**Device** TC27x  
**Marking/Step** ES-DC, DC  
**Package** see Data Sheet

## 10216AERRA

This Errata Sheet describes the deviations from the current user documentation.

**Figure 1 Message buffer transfer from Message RAM to OBF**

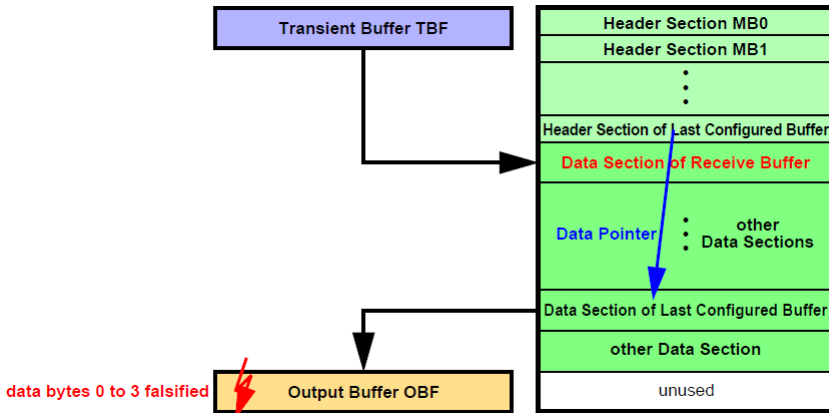
When the message buffer has its payload configured to maximum length (**PLC** = 127), the OBF word on address 00h (payload data bytes 0 to 3) is overwritten with unexpected data at the end of the transfer.

a) When a message is transferred from the Last Configured Buffer in the Message RAM to the OBF and **PLC** = 127 it may happen, that at the end of the transfer the OBF word on address 00h (payload data bytes 0 to 3) is overwritten with unexpected data (see [Figure 1](#)).

**Figure 2 Message buffer transfer from IBF to Message RAM**

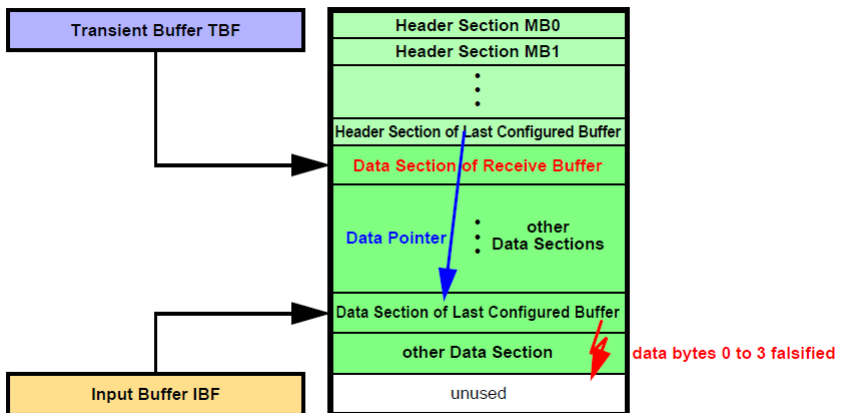
After the Data Section of the selected message buffer in the Message RAM has been written, one additional write access overwrites the following word in the Message RAM which might be the first word of the next Data Section.

b) When a message is transferred from IBF to the Last Configured Buffer in the Message RAM, it may happen, that at the end of the transfer of the Data Section one additional write access overwrites the following word, which may be the first word of another message's Data Section in the Message RAM (see [Figure 2](#)).

**Figure 3 Message RAM Configurations**

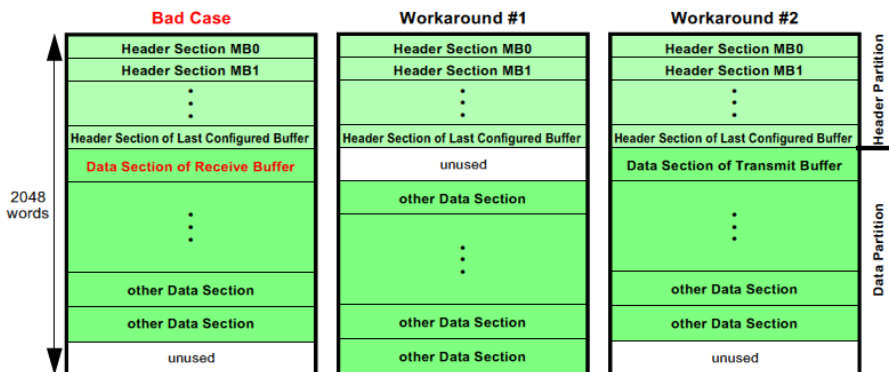
The erratum is limited to the case when (see [Figure 3](#) “Bad Case”):

2) Ensure that the Data Section directly following the Header Partition is assigned to a transmit buffer.

**Figure 5 Recommended Software Handling - Flowchart**

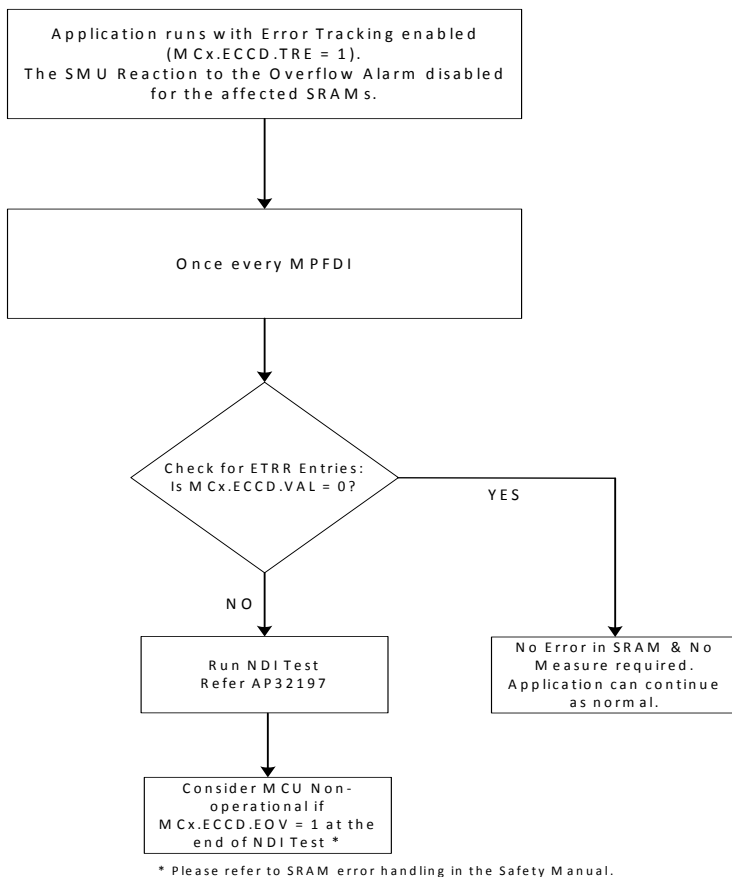
A flowchart of the recommended software handling is shown in [Figure 5](#).

If there is at least one valid ETRR entry (i.e.  $MCx.ECCD.VAL \neq 0$ ) then the software shall run a Non-Destructive-Inversion (NDI) Test on the affected SRAM. Please refer to application note AP32197 (AURIX™ Memory tests using the MTU) for an example regarding running this test.

At the end of this test, if an ETRR overflow is detected ( $MCx.ECCD.EOV = 1_B$ ) then the MCU shall be considered non-operational. Refer to section on Correctable SRAM Error handling in the Safety Manual.

**Figure 14** Ripple Voltage vs. Frequency Characteristic

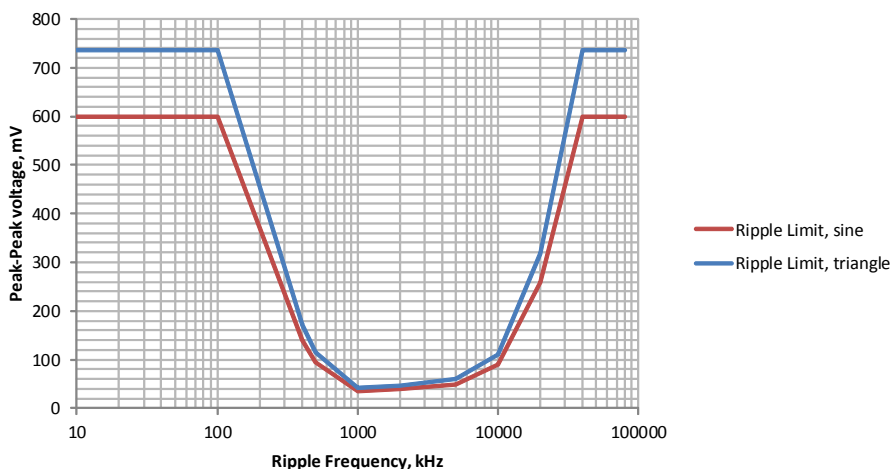
The internal back-up clock is sensitive to specific power supply voltage disturbance/ripple caused by a voltage ripple intrinsic to DC-DC converters. Specific conditions such as insufficient filtering of the ripple may lead to improper behavior of the start-up scheme of the back-up clock, and thus stuck-at state during the start-up of the microcontroller until this condition is removed.

The diagram reflects acceptable ripple level during the cold start of the microcontroller at the respective VDDP3/VEXT/VEVRSB supply of the PMS subsystem, depending on the device and package type, as shown in the following table.

**Figure 16 SENT Tolerance of this Design Step**

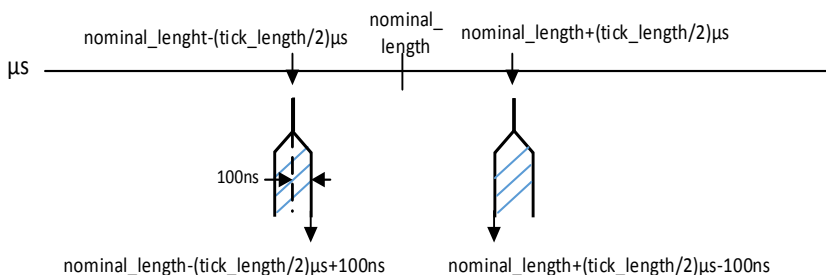
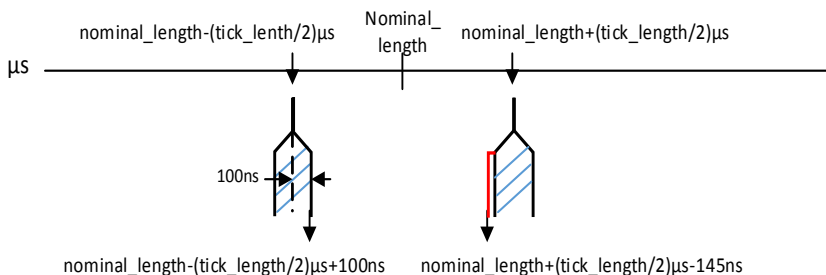
In this design step the range is delimited as follows:

- The lower border is  $\text{nominal\_value} - (\text{tick\_length}/2) \mu\text{s} + 100 \text{ ns}$
- The upper border is  $\text{nominal\_value} + (\text{tick\_length}/2) \mu\text{s} - 145 \text{ ns}$ .

**Figure 17 Short Serial Message, Serial Data Encoding over 16 messages**

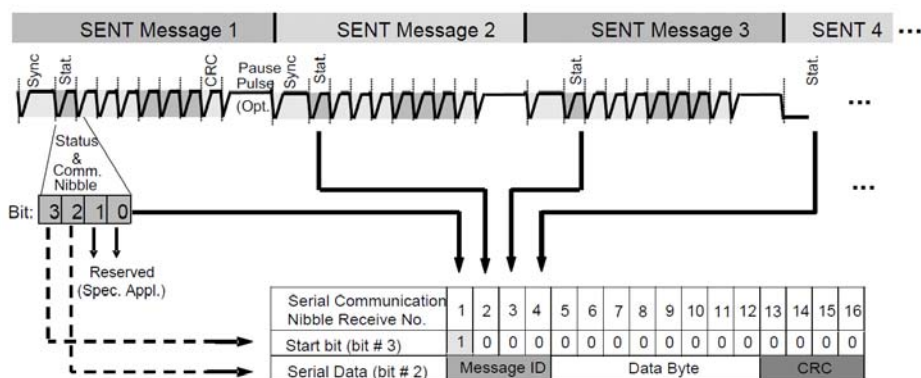
In Figure “Short Serial Message, Serial Data Encoding over 16 messages” of the SENT chapter, the arrows originating from bits 2 and 3 of the Status & Comm Nibble are routed incorrectly and must be swapped.

**Figure 17** shows a corrected version of this figure.
